**SUBJECT: Indian Point Nuclear Generating Unit No. 2  
Docket No. 50-247  
Response to NRC Request for Additional Information  
Re: "Proposed Change to Technical Specifications:  
One-Time Change to the Indian Point 2 Steam  
Generator Tube Inspection Requirements (TAC No. MC1260)"**

**RESPONSE TO NRC 02/19/04 RAI RE:  
PROPOSED CHANGE TO TECHNICAL SPECIFICATIONS:  
ONE-TIME CHANGE TO THE INDIAN POINT 2 STEAM  
GENERATOR TUBE INSPECTION REQUIREMENTS**

Entergy Nuclear Northeast  
Indian Point Unit 2  
**Response to RAIs Regarding Tube Stabilization and AVB Growth**

Figure 1.1  
Stabilization Criterion

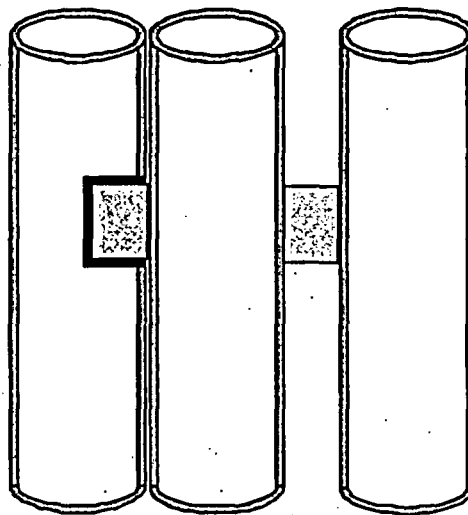
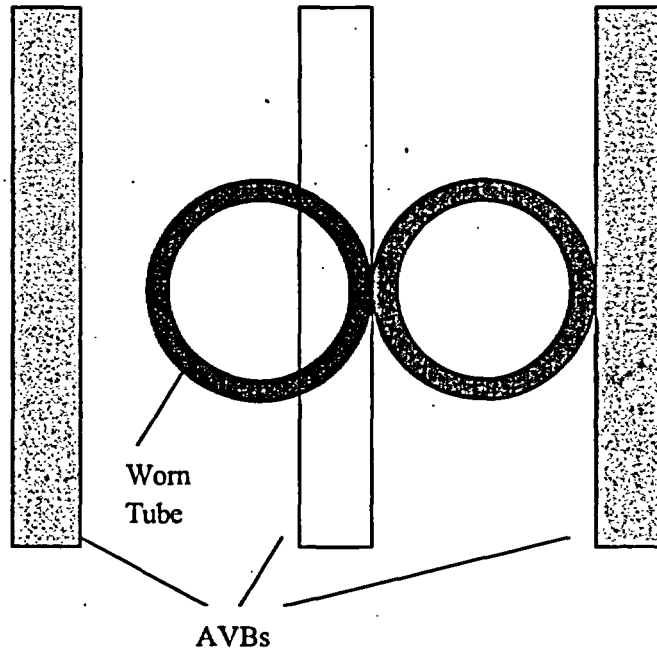
1. The licensee states that two of thirteen tubes found with anti-vibration bar (AVB) wear indications will be evaluated for stabilization prior to the next scheduled inspection. The licensee states that these two tubes had indications at all four AVB contact points and are not expected to wear to the point of causing tube to tube contact for the next four cycles. Provide a brief summary of the method used for performing this evaluation. State whether the remaining eleven tubes will also be evaluated for future stabilization? If not evaluated, discuss the reason?

The criterion that has been used by Westinghouse for all wear projection evaluations performed over about ten years for stabilization recommendations is prevention of tube-to-tube contact as illustrated on Figure 1.1. At the point of tube to tube contact, wear would be expected to occur on the adjacent tube. However, this does not meet the definition of uncontrolled damage propagation, similar to the condition observed at TMI (Ref 1). For uncontrolled damage propagation, separation of the plugged tube is required, i.e., at the point of the AVB wear. Tube to tube contact occurs when the wear is approximately 35% through the cross-section of the tube. Significantly greater damage to the cross-section of the tube is required before separation of the tube due to fatigue would occur. Prior to that condition, wear on the adjacent active tube(s) would be observed.

35-40% Through-Section Wear

Tube worn into AVB  
to the point where  
tube makes contact  
with neighboring tube

Figure 2.1  
AVB Wear Sizing Correlation  
(630/160 Differential Mix; 20/40/70 Standard)

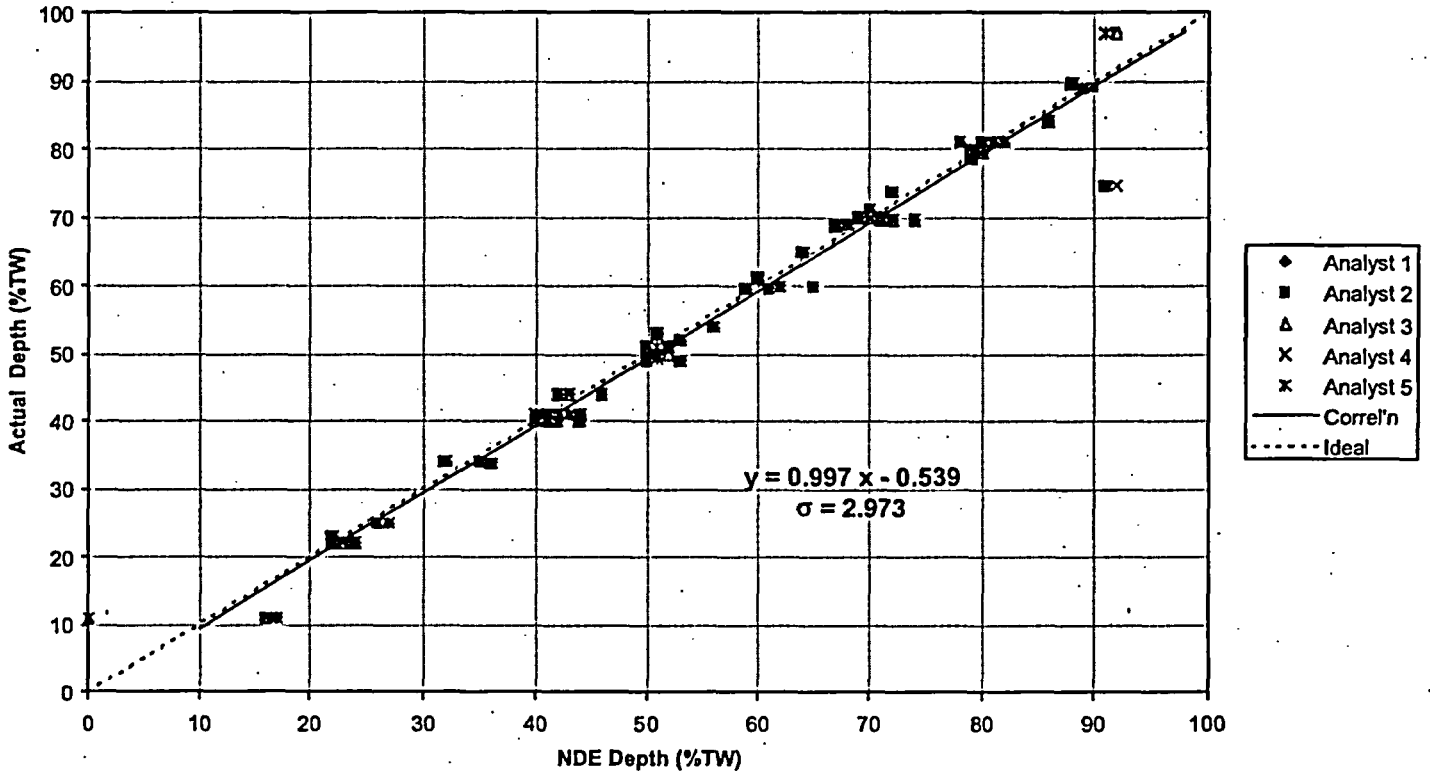
2. *The licensee states that as a result of the implementation of a 1.4% power uprate, the amount of wear expected over a 40-year lifetime is 2 mils (4% of the tube wall thickness), which is less than the allowable 3 mils. Provide additional clarification on this estimate since it seems to be at odds with experience to date at IP2 where thirteen tubes exhibited wear ranging between 5% (the detection threshold) and 20% of the wall thickness after just one operating cycle. Presumably, there may be undetected wear flaws which grew by as much as 5% over the first operating cycle, prior to the 1.4% power uprate.*

The uncertainty correlation shown on Figure 2.1 represents the total uncertainty of the technique and the analysts. It includes the 2-sided specimen data, but excludes the tapered data based on the rationale presented above. The correlation shows that the sizing technique tends to overestimate the actual depth slightly (<1%) over the entire range of depths tested. The 95% CL value of uncertainty is approximately 4.3% at a wear depth of 75% TW. Application of sizing uncertainties specified here are contingent upon use of 20%/40%/70% depth AVB wear scar standard for indications greater than about 50%TW. For wear depth less than about 50% TW, there is essentially no difference in uncertainties when using a

0/20/40 standard or using a 20/40/70 standard. For conservatism a 5% uncertainty will be used in this evaluation.

Although this correlation was developed for 11/16" diameter A600TT tubing, no significant differences would be expected for the 7/8" A600TT tubing at IP2.
